File Number	PL 22-141	Contact	Kyle Deming	
Type	Preliminary Plat	Planning Commission Date		September 13, 2022
Deadline for Action	Application Date	August 9, 2022	60 Days	October 8, 2022
	Date Extension Letter Mailed	August 26, 2022	120 Days	December 7, 2022
Location of Subject	South and east of the intersection of Anderson Rd. and Decker Rd. (Piedmont Heights)			
Applicant	HNH LLC (Lon Hovland – Owner) and Michael and Kathleen Wilson (owners)	Contact	Available, on file	
Agent	Northland Consulting Engineers – David Bolf; Alta Land Survey Co. – David	Contact	Available, on file	
Legal Description	See Attached Map			
Site Visit Date	August 26, 2022	Sign Notice Date		August 29, 2022
Neighbor Letter Date	August 26, 2022	Number of Letters Sent		59

Proposal: Approval of the preliminary plat of REARRANGEMENT OF PART OF WESTERN WOODS DIVISION to provide for re-platting of 17 lots and a 3 acre unplatted parcel totaling 11.3 acres into 19 lots on a shortened street. The proposal includes construction of a new public street with sidewalk and utilities.

PL 22-141
 Preliminary Plat
 Rearrangement of Part
 of Western Woods

PRELIMINARY PLAT OF REARRANGEMENT OF PART OF WESTERN WOODS

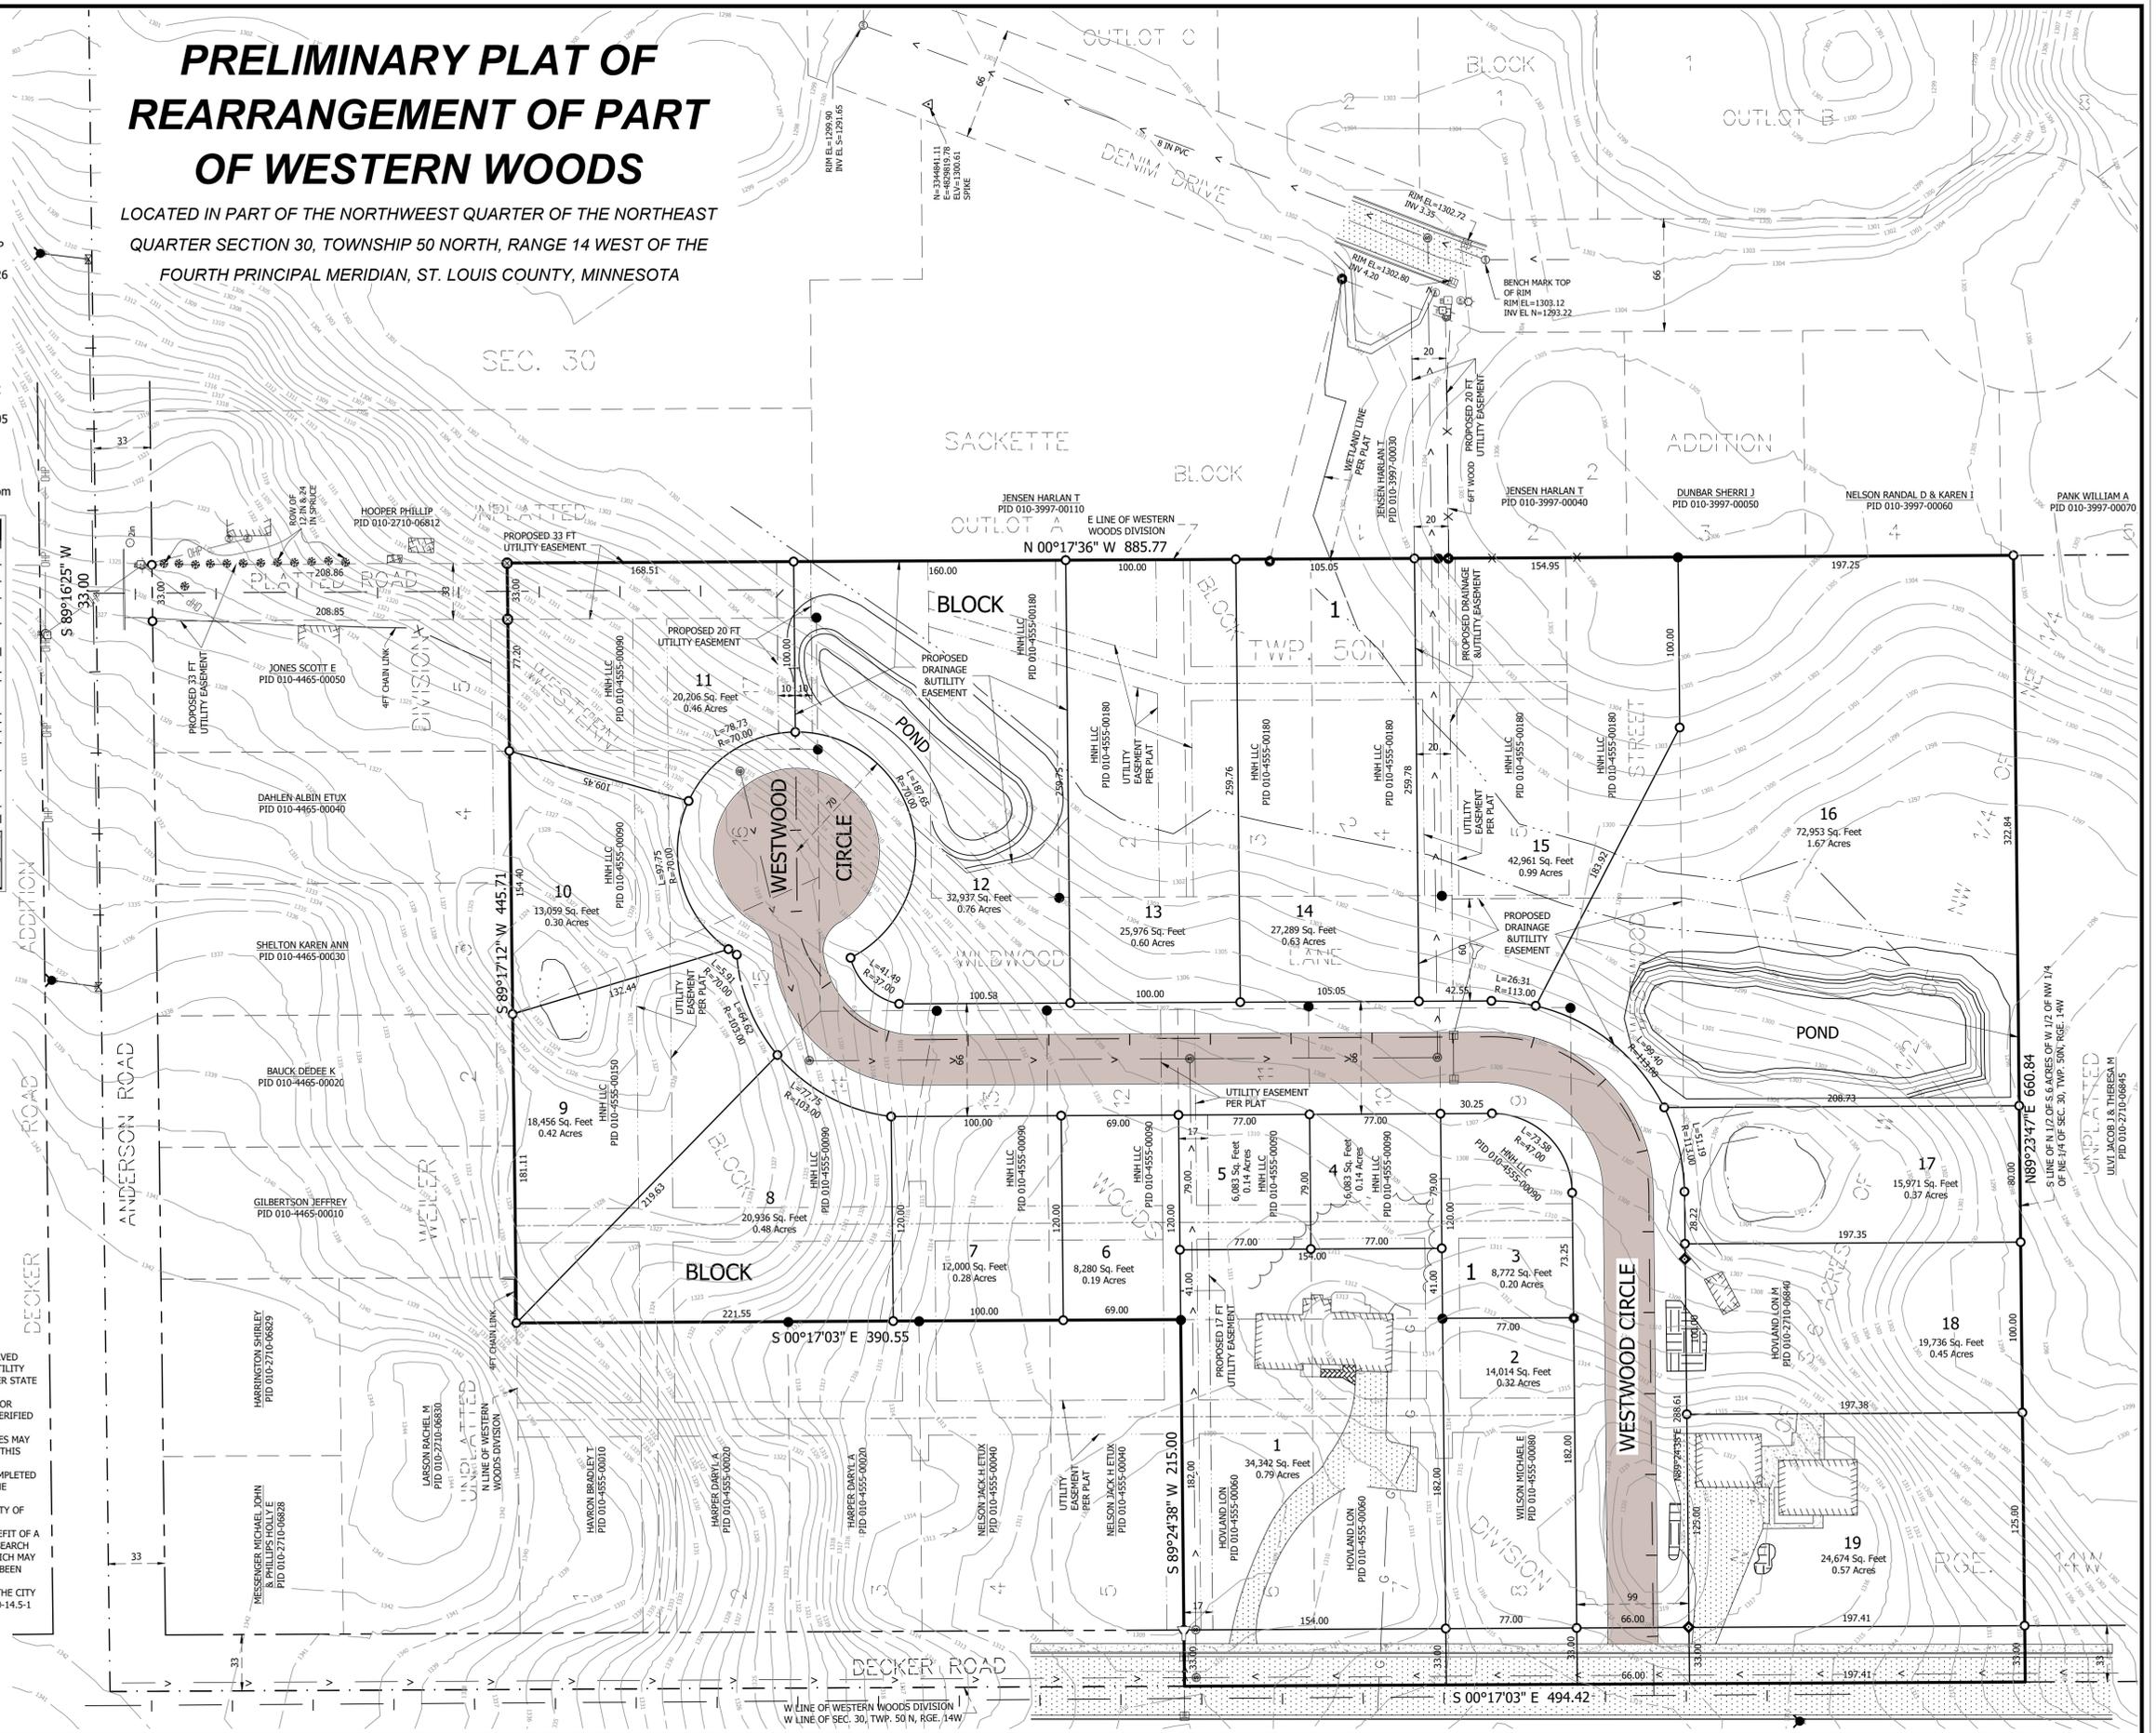
- 9) Storm Water. A preliminary drainage report and storm water system layout has been provided by the civil engineer and is not yet approved by City Engineering. Two storm water detention basins are planned for the east side of Westwood Cir., discharging to the wetland corridor in Lots 12-16. The City Engineer commented that these facilities need to be located in utility easements, which is a recommended condition of approval of the plat. Additional study is requested to document existing drainage patterns compared to proposed drainage patterns so the size of the detention basins can be calculated and verified by the City's storm water engineer. Additional BMPs may be needed to capture and treat areas not draining to the storm water basins shown. Lots 15 and 16 will require driveways that cross the wetland corridor. Lastly, because the site drains to Miller Creek, a trout stream, the wetlands are critically important for stream viability and there is concern that development on Lots 13 and 14 will result in wetland impacts due to the depth of the lots. Any wetland impacts need to be accounted for in the sizing of the storm water treatment basins.

- 13) City Staff Comments. The City Engineering division has reviewed the proposed stormwater management systems and the proposed public street, and provided feedback. The City's property services specialist commented that the plat boundaries extend to Anderson Rd. and Decker Rd. covering existing platted streets, which may not be necessary. This will be resolved for the final plat.
- 14) The approval of the Preliminary Plat of REARRANGEMENT OF PART OF WESTERN WOODS DIVISION is contingent on the City Council's approval of the vacation of existing streets and utility easements in the area to be re-platted (file no. PL21-158).

2. The final plat shall be drafted with modifications to the following elements depicted on the preliminary plat:
 - a. Drainage and utility easements shall be provided over wetlands on those portions of Lots 12-16. Permanent metallic markers on rigid metal posts shall be placed at the location of wetland boundaries with signs indicating the presence of wetlands to be left in a natural state.

- b. Stormwater treatment facilities shall be sized and located in utility easements as approved by City Engineering.
 - c. Plat boundaries be adjusted in the area of existing streets relative to surveying and legal requirements.

- b. A pedestrian easement through Lot 11 connecting the cul du sac to Anderson Rd. shall be conveyed to the public and its presence noted on the Final Plat.
